## Permit to Alter Case Report

*Hearing Date:* August 15, 2012  
*Filing Date:* July 23, 2012  
*Case No.:* 2012.0502H  
*Project Address:* 1355 MARKET STREET (aka 1301-1363 MARKET STREET)  
*Conservation District:* N/A  
*Category:* Category I (Significant) – Western Furniture Exchange  
*Zoning:* C-3-G (Downtown General Commercial)  
120-X-200-S Height and Bulk District  
*Block/Lot:* 3508/001  
*Project Sponsor:* Elisa Skaggs  
Page & Turnbull  
1000 Sansome Street, Suite 200  
San Francisco, CA 94111  
*Staff Contact:* M. Pilar LaValley - (415) 575-9084  
[pilar.lavalley@sfgov.org](mailto:pilar.lavalley@sfgov.org)

ORIGINAL, EXISTING, AND PROPOSED SECTION DETAILS

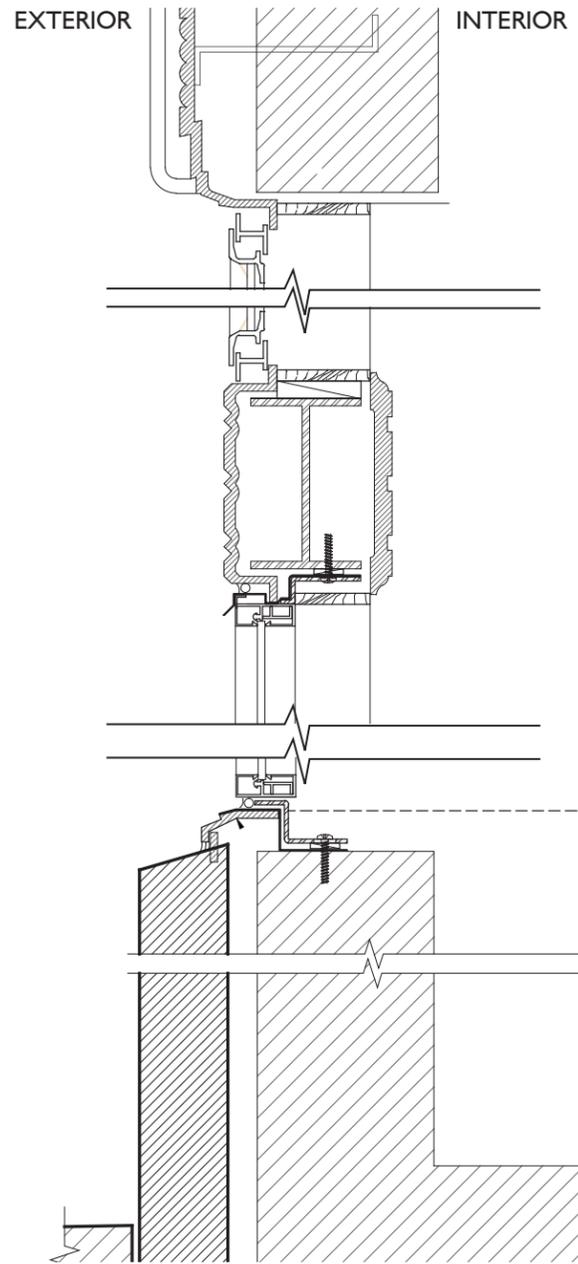
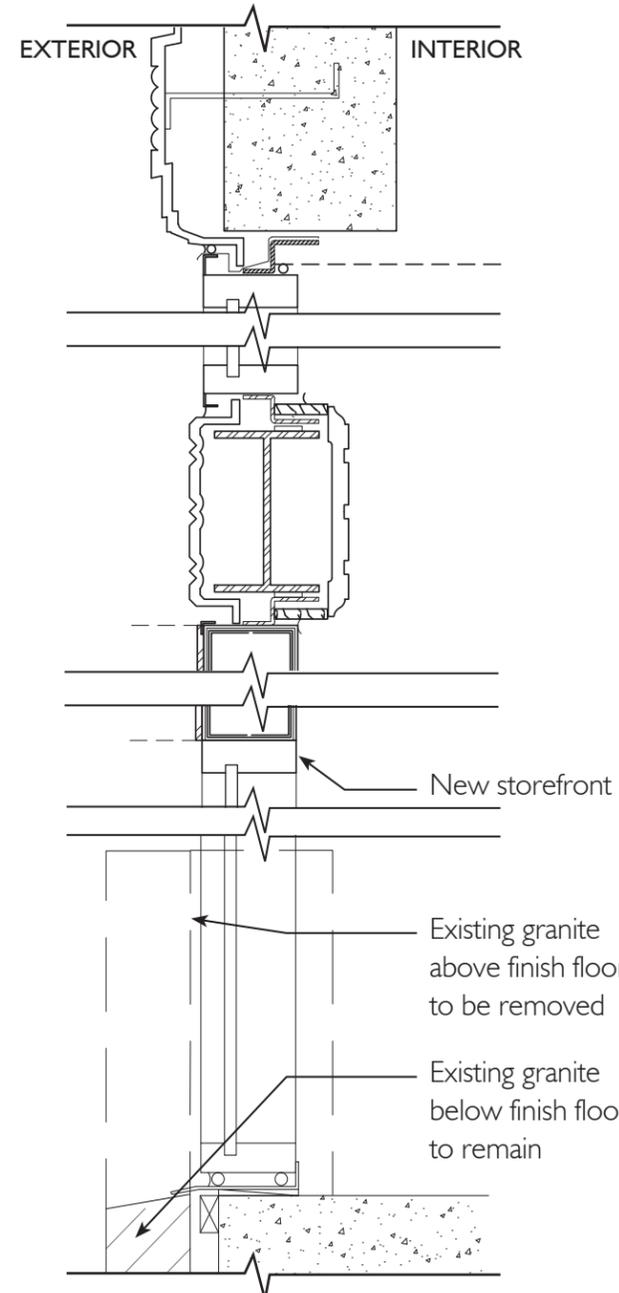
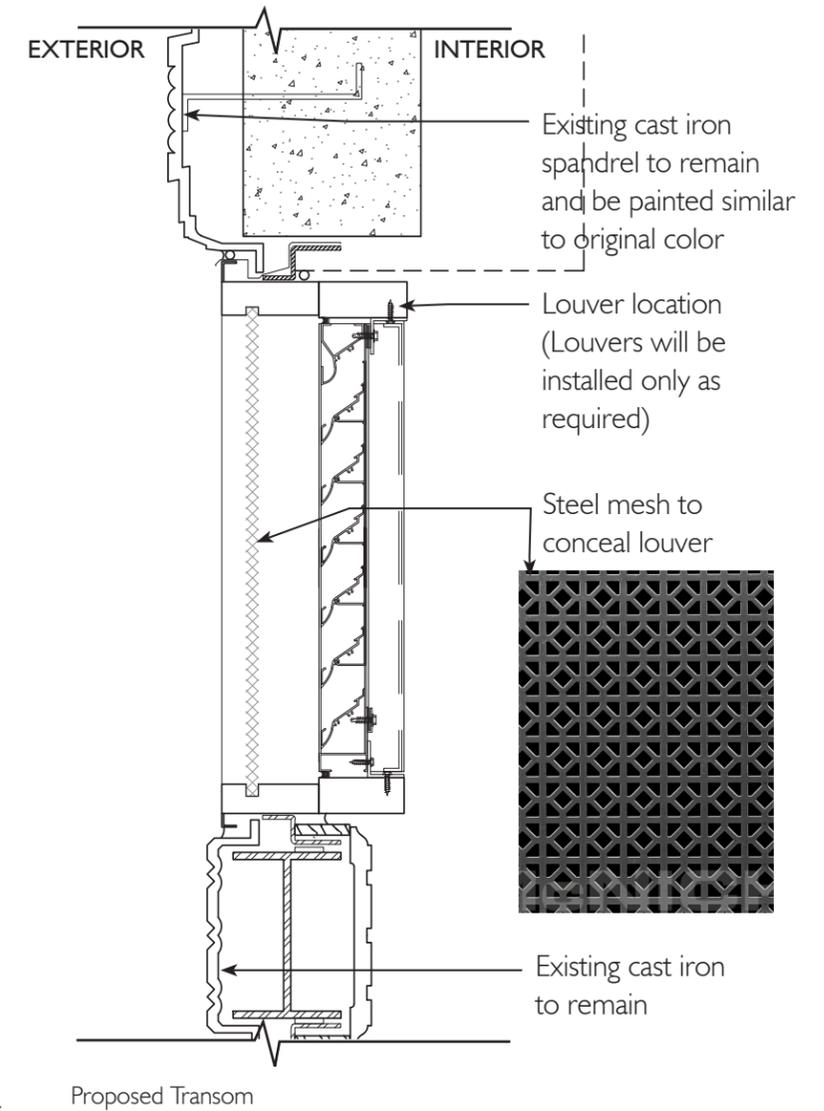
1. Section drawings that indicate all exterior profiles and dimensions of new storefront elements shall be provided, and are subject to review and approval prior to approval of the Building Permit by Planning Department staff.
2. Section and detail drawings for the proposed transom windows, including the adaptable transoms, shall be provided, and are subject to review and approval prior to approval of the Building Permit by Planning Department staff.
3. Material samples for storefront system, transom windows, and decorative grilles shall be provided, and are subject to review and approval prior to approval of the Building Permit by Planning Department staff.

2. Section and detail drawings for the proposed transom windows, including the adaptable transoms, shall be provided, and are subject to review and approval prior to approval of the Building Permit by Planning Department staff.

Proposed alterations to garage entry

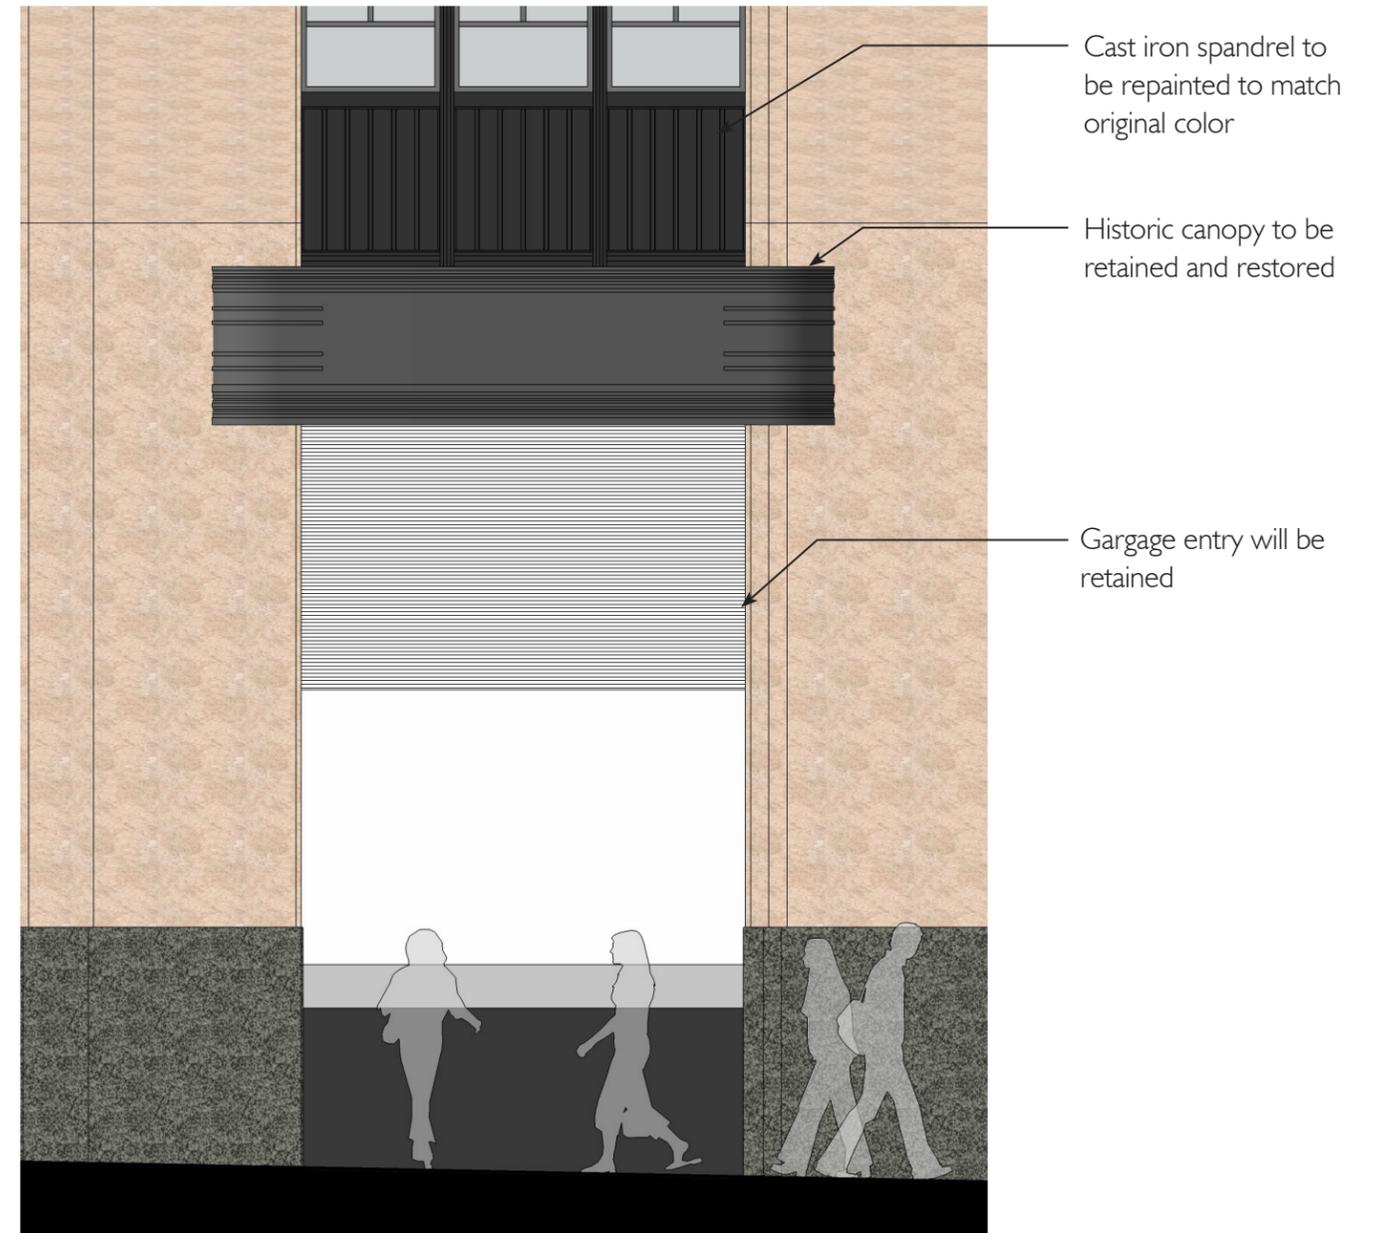
4. Detail drawings indicating all exterior profiles and dimensions of the rehabilitation and/or reconstruction of canopy elements beyond repair shall be provided, and are subject to review and approval prior to approval of the Building Permit by Planning Department staff.

Proposed window detail

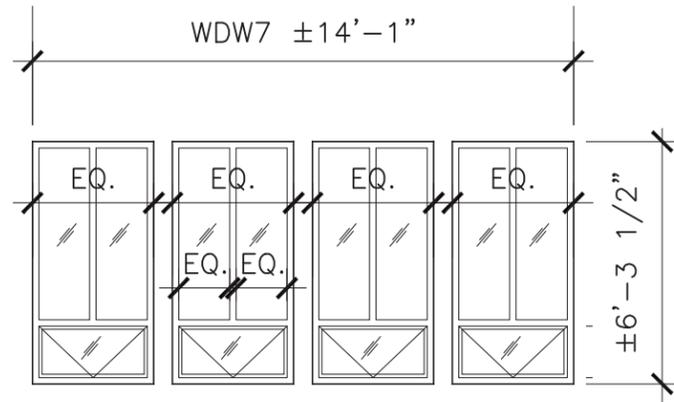
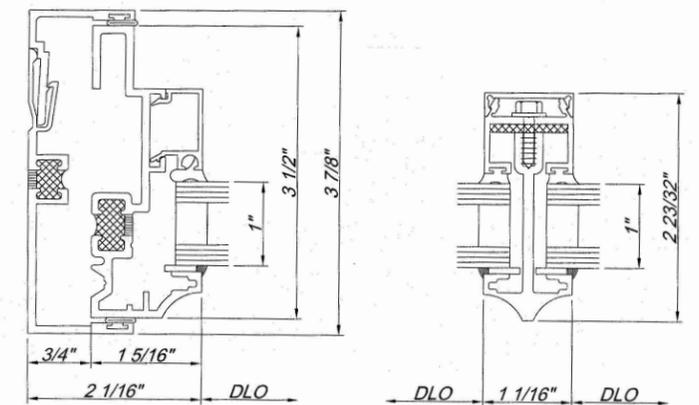
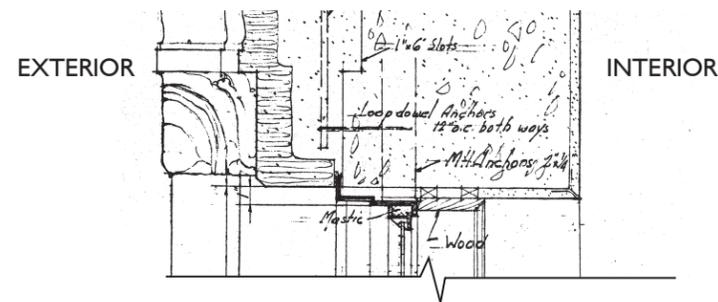
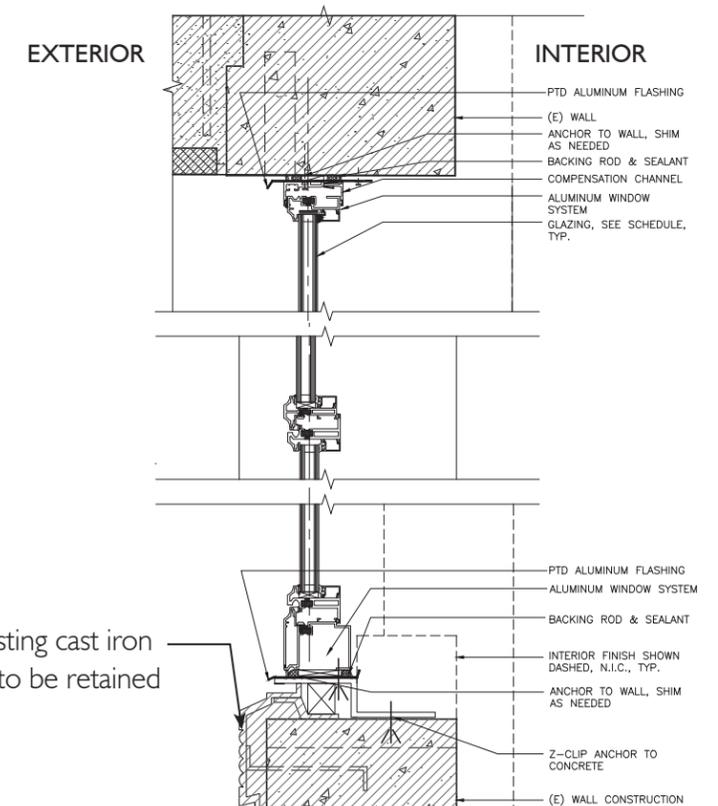
5. **Window sills at 2<sup>nd</sup> floor.** Commissioner Wolfram commented that in proposed drawings and renderings it appeared that the new sills at 2<sup>nd</sup> floor windows was getting bulkier, and recommended that this be revised such that the new sills match existing profiles. Commissioner Martinez agreed. Commissioner Hasz had no comment.

Detail of Proposed Windows at Tenth Floor

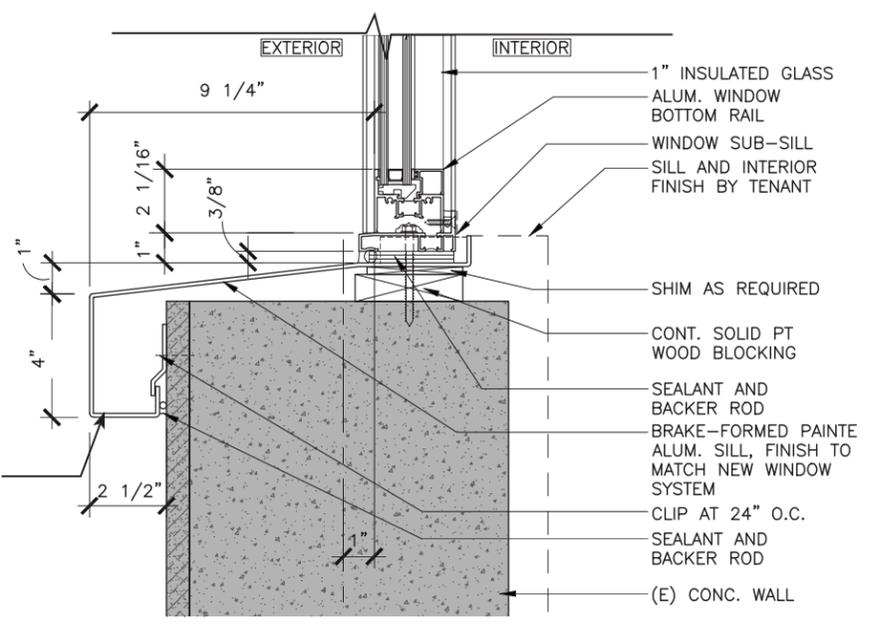
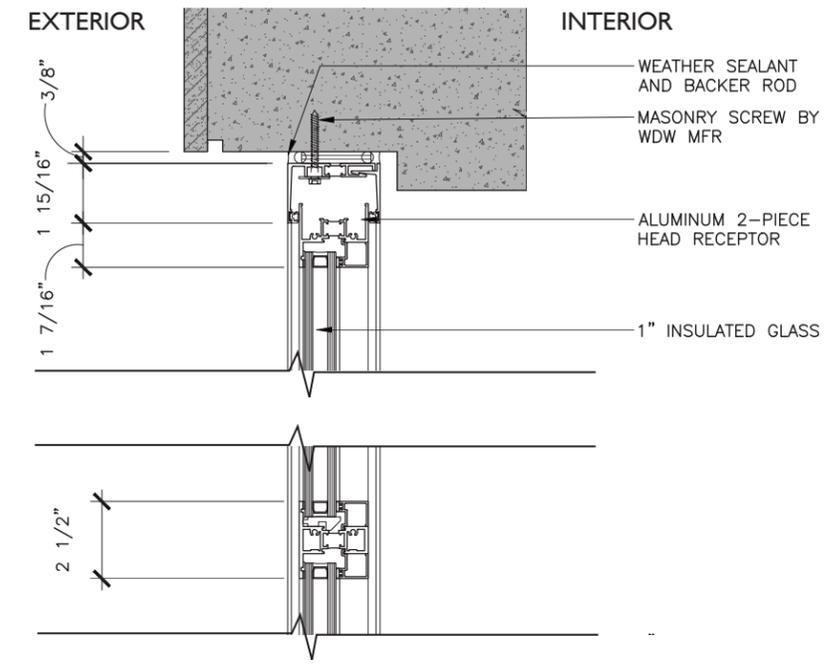
The proposal includes increasing the size of the 10<sup>th</sup> floor window openings by lowering the sill. At Market, Stevenson, and Jessie Streets, lowering the sill will require removal of stucco cladding on the non-historic 10<sup>th</sup> floor addition (from Market Street this change would be largely obscured by the 9<sup>th</sup> floor addition). At 9<sup>th</sup> Street, the lower sill will require removal of the existing cast stone sill and historic terra cotta cladding and alteration of the configuration and proportion of the parapet. An aluminum sill with profile to match the existing would be installed to cap the lowered parapet.

This portion of the parapet is from the 1947 addition of the 9<sup>th</sup> Street wing, which is within the period of significance for the building and is, therefore, historic fabric. Although this portion of the building was added during the period of significance, this section of the parapet is quite different from the more ornate bas-relief parapets with projecting pier caps that terminate the Market and 10<sup>th</sup> Street façades. This difference is due to the fact that at 9<sup>th</sup> Street, the 9<sup>th</sup> floor addition was constructed flush with the lower floors; on the other façades, the 9<sup>th</sup> floor addition was set back, allowing the decorative parapet to dominate. At 9<sup>th</sup> Street, the parapet consists of two courses of terra cotta blocks with a simple cast stone cap.

3. **Lowering sill at 10<sup>th</sup> floor windows.** Commissioner Wolfram stated that he disagreed with staff recommendation to remove the proposed scope from the project as he was comfortable with the proposal because of the height and uniqueness of the parapet condition at 9<sup>th</sup> Street. Commissioner Hasz agreed. Commissioner Wolfram was in agreement with staff recommendation that a sill and cap matching existing at the lowered parapet should be provided in architectural details with the Major Permit to Alter application. Commissioner Martinez disagreed with staff as well as Commissioner Wolfram as he feels that piers should continue to be the building's most prominent feature and that enlarged windows, in all locations, are inappropriate and, further, that historic fabric should not be removed for this purpose. Commissioner Martinez stated that he believed there were other alternatives to achieve the interior views desired by the Project Sponsor.

5. A new cast concrete sill matching the color, finish, and dimensions of existing shall be included as part of the proposal. A finish detail of this feature shall be provided, and is subject to review and approval prior to approval of the Building Permit by Planning Department staff.

Proposed detail of window washing equipment installed through the wall at the tower

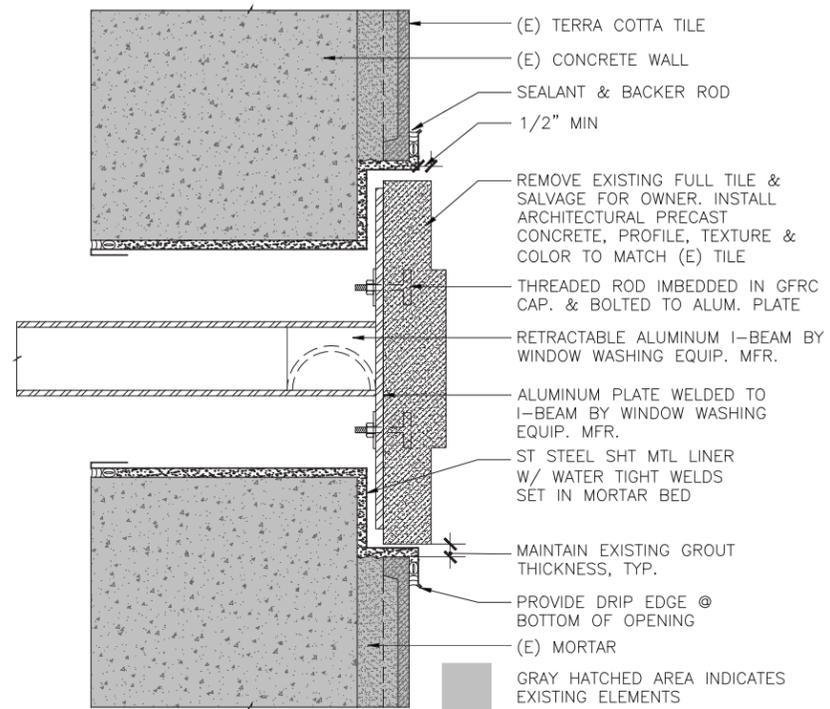
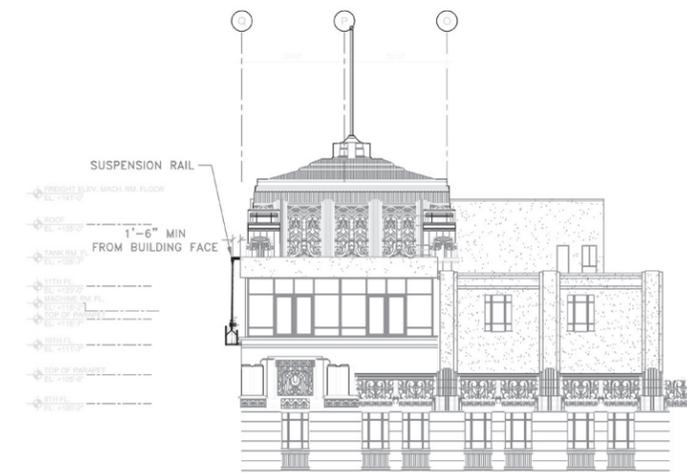
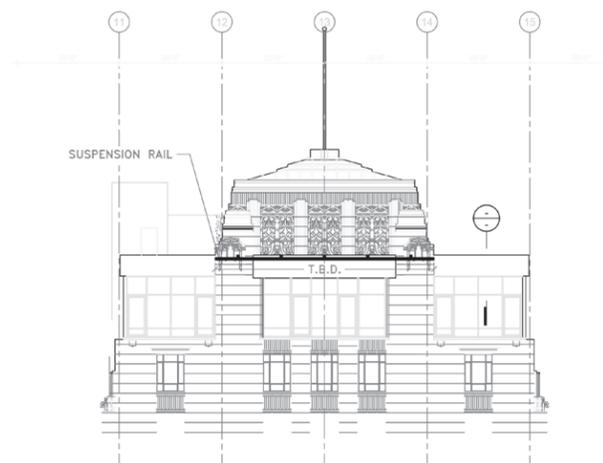
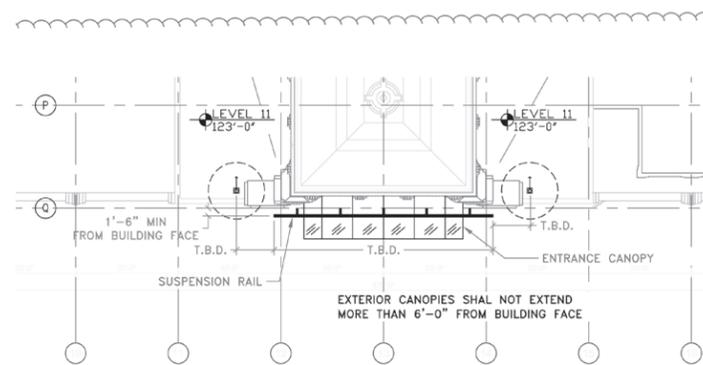
6. Details of the attachment mechanisms for the window washing equipment at the façade shall be provided. Details and finish samples of the cast units, should the terra cotta tiles be replaced, are subject to review and approval prior to approval of the Building Permit by Planning Department staff.
